**H. B. ROBINSON STEAM ELECTRIC PLANT, UNIT NO. 2
DOCKET NO. 50-261/RENEWED LICENSE NO. DPR-23**

Subject: Completion of Required Actions for NRC Order EA-12-051 With Regard to Reliable Spent Fuel Pool Level Instrumentation

**DUKE ENERGY'S RESPONSE TO
SPENT FUEL POOL LEVEL INSTRUMENTATION (SFPLI) REQUEST FOR
ADDITIONAL INFORMATION (RAI's) AND SAFETY EVALUATION
REVIEW ITEM #7**

H. B. ROBINSON RESPONSES TO SFPLI RAIs AND SAFETY EVALUATION REVIEW ITEM #7

Refer to the Sketch below titled “NRC Response Sketch 1” for locations of the radar, waveguide horn, tubing and sensor locations. As shown on the sketch, both sensors will be located on the outside wall of the spent fuel pool.

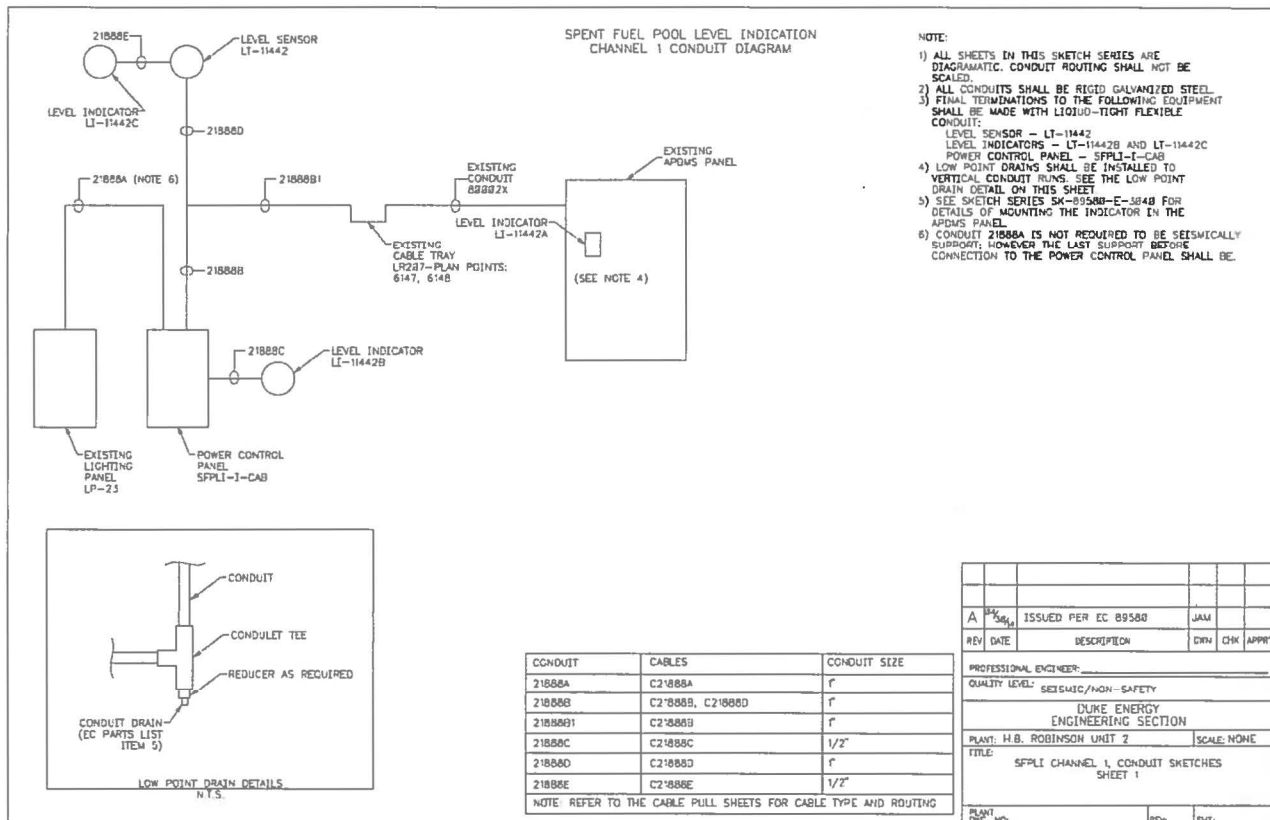
Please provide a clearly labeled sketch or marked-up plant drawing of the plan view of the SFP area, depicting the SFP inside dimensions, the planned locations/placement of the primary and back-up SFP level sensor, and the proposed routing of the cables that will extend from these sensors toward the location of the read-out/display device.

Conduit from the sensors to the indicators will be routed as shown on sketch series SK-89580-E-3020 and SK-89580-E-3030 of EC 89580 (As shown below). In general, conduit for one channel of level will be routed across the roof of the Reactor Auxiliary Building to the Control Room. The other channel's conduit will be routed along the outside of the Reactor Auxiliary Building on the north and east walls.

The routing for this line is shown on Sketch SK-89580-M-2000 and is different from that of sensing line Channel 2. The span inside the fuel handling building is long and needs a support inside the building and is evaluated as discussed below.

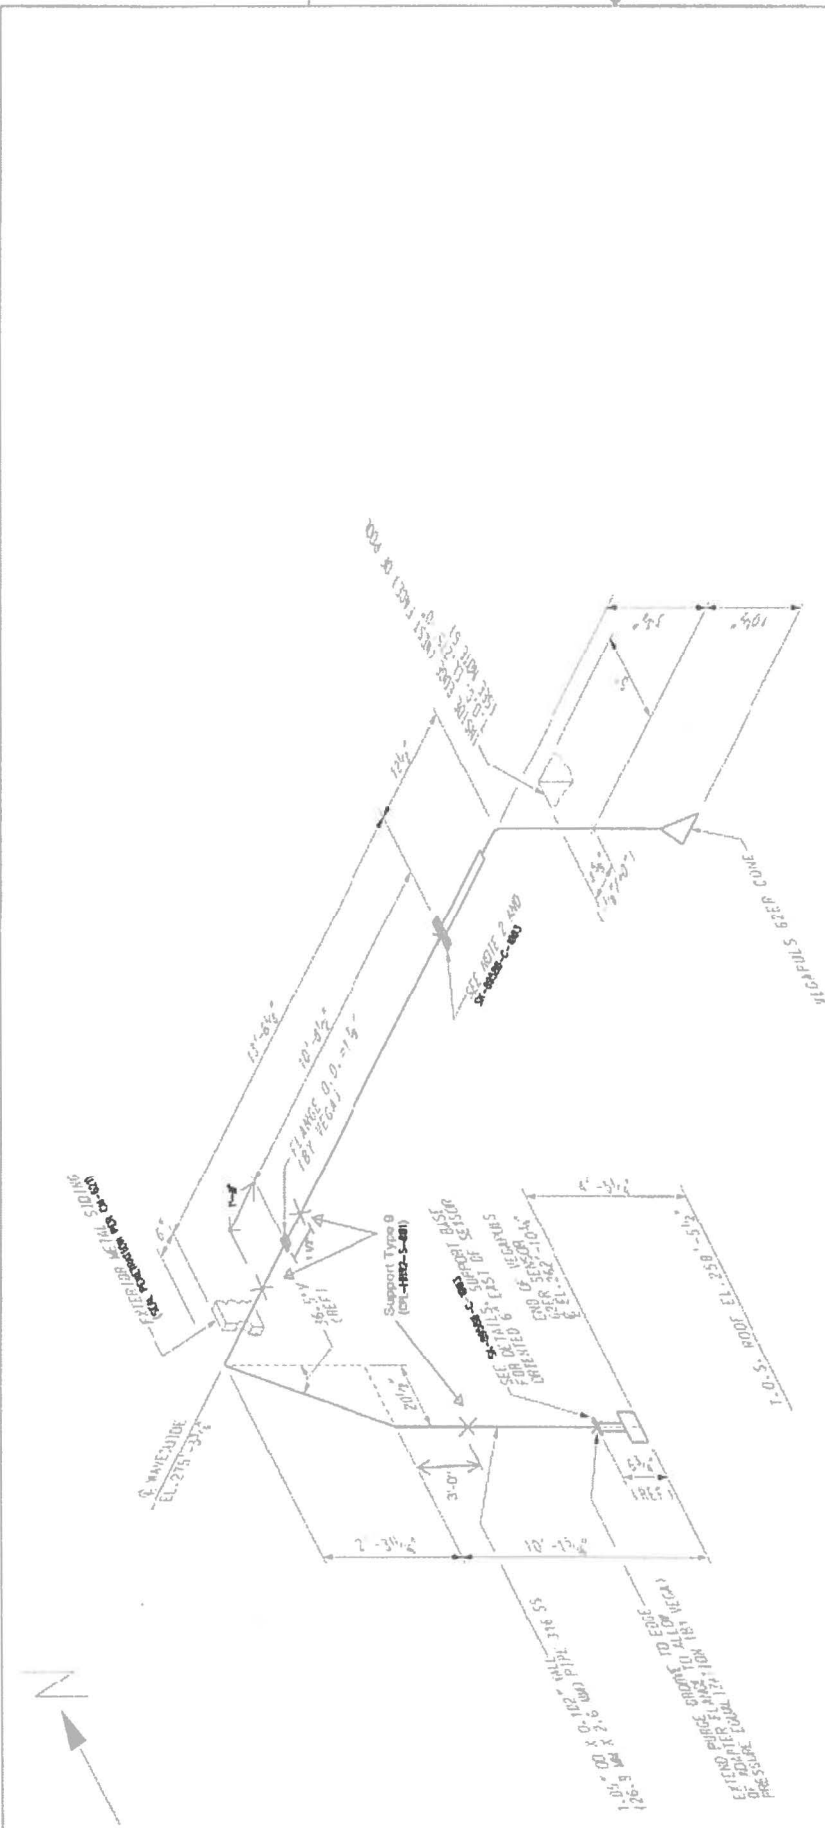
- A description of the manner in which the level sensor (and stilling well, if appropriate) will be attached to the refueling floor and/or other support structures for each planned point of attachment of the probe assembly. Indicate in a schematic the portions of the level sensor that will serve as points of attachment for mechanical/mounting or electrical connections.**

- b) There are two level sensing lines (waveguides) added per this modification. One waveguide is installed at the southeast side of the spent fuel pool identified as waveguide sensing line Channel 2 and the second waveguide is installed at the northwest side of the spent fuel pool identified as waveguide sensing line Channel 1.

Sensing Line Channel 1
